Safety Evaluation Report

Renewal of the Facility Operating License for the GE-Hitachi Nuclear Test Reactor

License No. R-33
Docket No. 50-073

United States Nuclear Regulatory Commission

Figure 2-1: Fuel Container Assembly (SAR Figure 4-2)

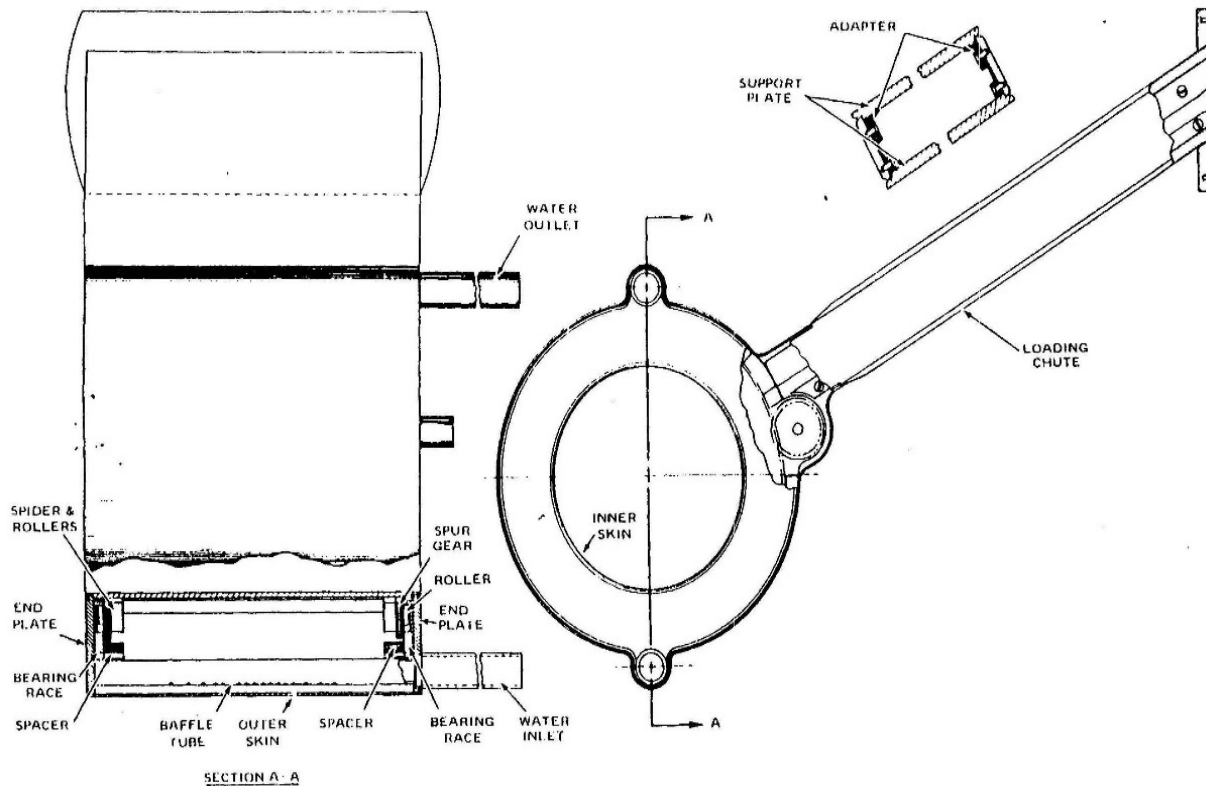
SAR section 4.2 also states that the fuel assemblies are supported by a core reel assembly. The core reel assembly is supported and guided by circular raceways in the end plates of the core can. A reel drive mechanism rotates the entire reel assembly to a desired position. The fuel loading chute is attached to the outer wall of the core can, inclined at an angle of approximately 30 degrees above horizontal. The aluminum loading chute is rectangular and is roughly 30 inches (in.) (76 centimeters (cm)) long, 20 in. (51 cm) wide, and 3 in. (8 cm) high. Slotted adapters in the chute both provide a guide for the aluminum-clad graphite chute plug and for the fuel loading tool during refueling operations. The fuel container assembly is shown in figure 2-1, "Fuel Container Assembly," below.

The NRC staff reviewed the information provided in SAR section 4.2.1 and finds that it provides an accurate description of the NTR reactor fuel. The NRC staff finds that the licensee has described in detail the dimensions of the fuel elements to be used in the reactor. The NRC staff finds that SAR section 4.2.1 is consistent with the guidance in NUREG-1537, Part 2, section 4.2.1, "Reactor Fuel," which states that the licensee should describe in detail the fuel elements to be used in the reactor. As stated in its SE issued with LA No. 21, the NRC staff found the reactor fuel acceptable. Given that the licensee has proposed no changes to the reactor fuel, the NRC staff continues to find the NTR reactor fuel acceptable.

Figure 2-2: Reactor Power and Hot Spot Fuel Temperature Versus Time, \$0.76 Step from Source Level, 55°F Coolant Inlet Temperature – No Scram (SAR Figure 13-10)

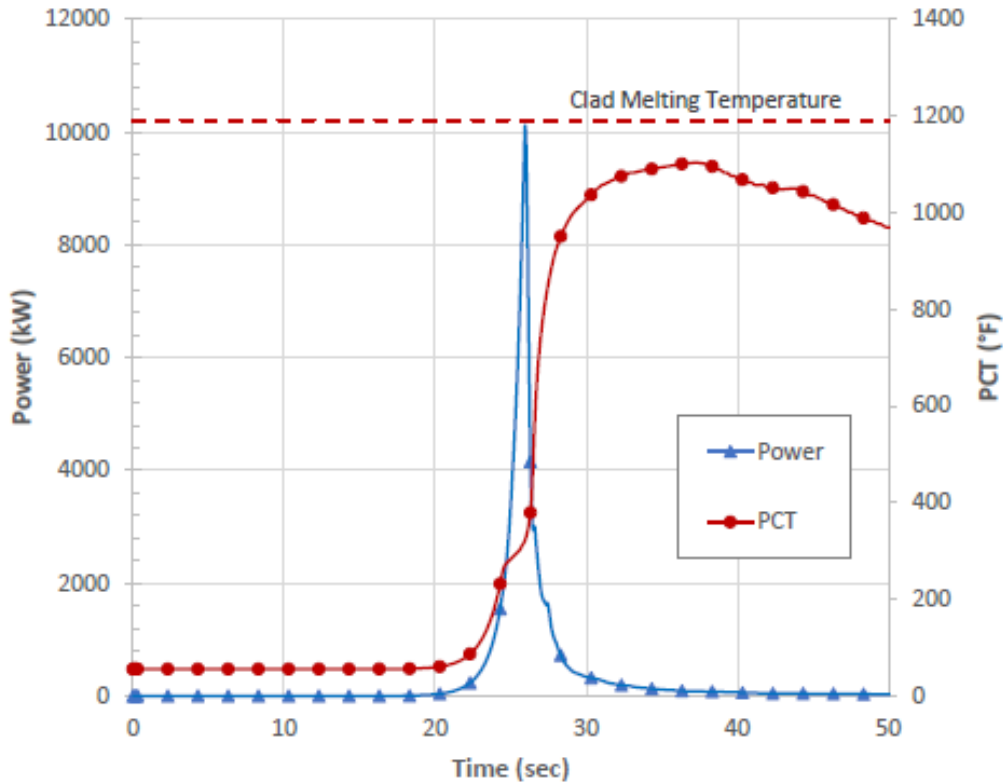
SAR section 4.4.3 states that the potential excess reactivity is limited to \$0.76. Further, SAR section 13.5.3 states that a \$0.76 step reactivity insertion with failure to scram would not result in fuel failure or the release of fission products. The SAR states that in order to determine the effects of positive reactivity additions from less than full power and temperature, additional transients were run with an initial power level of 1×10^{-7} kW. Inlet water temperatures ranged from 55°F to 90°F (12.8°C to 32.2°C) and the initial positive reactivity step of \$0.76. Results show that the positive reactivity feedback from the temperature coefficient is more important for the zero-power cases because coolant temperatures are lower. Reactor power and peak fuel temperature versus time for a \$0.76 step insertion from 1×10^{-7} kW and 55°F (12.8°C) inlet water temperature is given in SAR figure 13-10 (reproduced as figure 2-2, "Reactor Power and Hot Spot Fuel Temperature Versus Time, \$0.76 Step from Source Level, 55°F Coolant Inlet Temperature – No Scram," below). As shown in figure 2-2 below, limiting the step reactivity to \$0.76 or less ensures that the peak cladding temperature remains below the clad melting temperature, and thus there are no mechanisms available that will cause fuel damage.

In its response to audit question 026, the licensee stated that reactivity insertion due to graphite temperature change is not actively factored into excess reactivity calculations. The licensee also stated that graphite temperature increases from approximately 70-80°F (21-27°C) at startup to between 120°F (49°C) and 140°F (60°C) after 3-4 hours of operation at full power. The NRC staff finds that not factoring graphite temperature into the excess reactivity limit is appropriate because graphite temperature change will be gradual and the potential excess reactivity limit is based on the step insertion of reactivity transient. Additionally, analysis of ramp reactivity insertions in SAR section 13.5.2, “Idealized Finite Ramp Reactivity Insertions – with Scram,” does not depend on the potential excess reactivity limit, and analyzed reactivity insertion rates far exceed that achievable through graphite heating. Potential excess reactivity is also used to calculate shutdown margin, which is discussed in SER 2.5.3.4, “Shutdown Margin,” which was evaluated by the NRC staff and found to be acceptable.

The NRC staff finds that the licensee’s analysis considers all design features and feedback mechanisms contributing to excess reactivity. The discussion of the limits on excess reactivity shows that credible failures that instantaneously add reactivity would not lead to loss of fuel integrity and, therefore, would not cause unacceptable risk to the public from a transient.

Figure 6-1 Facility Organization

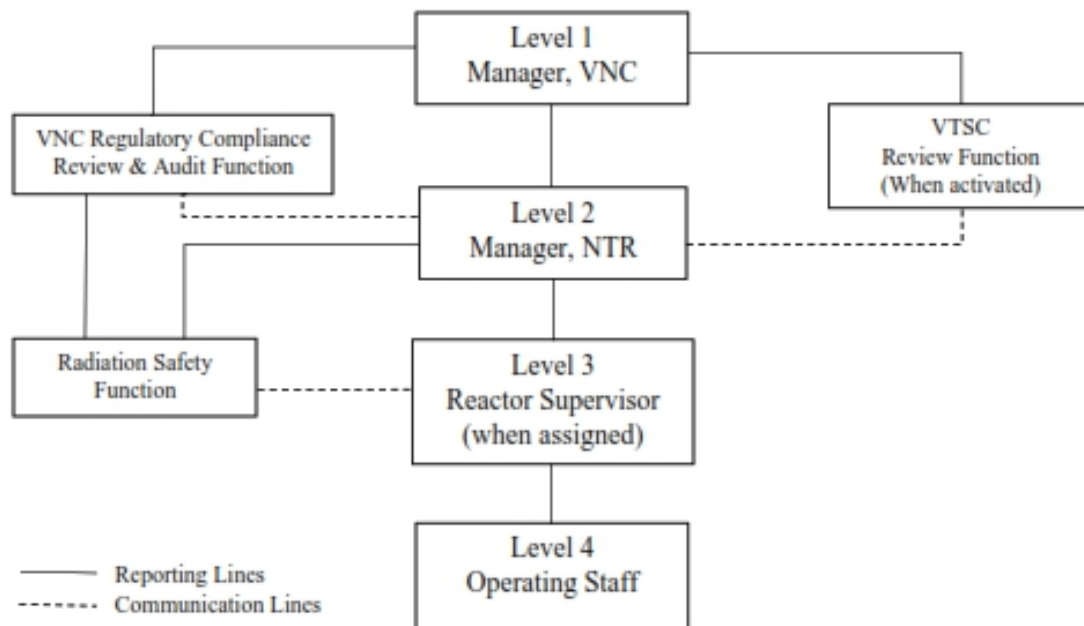
Proposed TS 6.1.1, "Structure," is Figure 6-1, "Facility Organization," which is reproduced below:

The NRC staff reviewed proposed TS 6.1.1 and finds that it is consistent with the guidance in NUREG-1537, Part 1, appendix 14.1, section 6.1.1, "Structure," and ANSI/ANS-15.1-2007, section 6.1.1, "Structure," which states that the structure should follow the guidance in the Figure 1 organization chart. Based on the above, the NRC staff concludes that proposed TS 6.1.1 is acceptable.
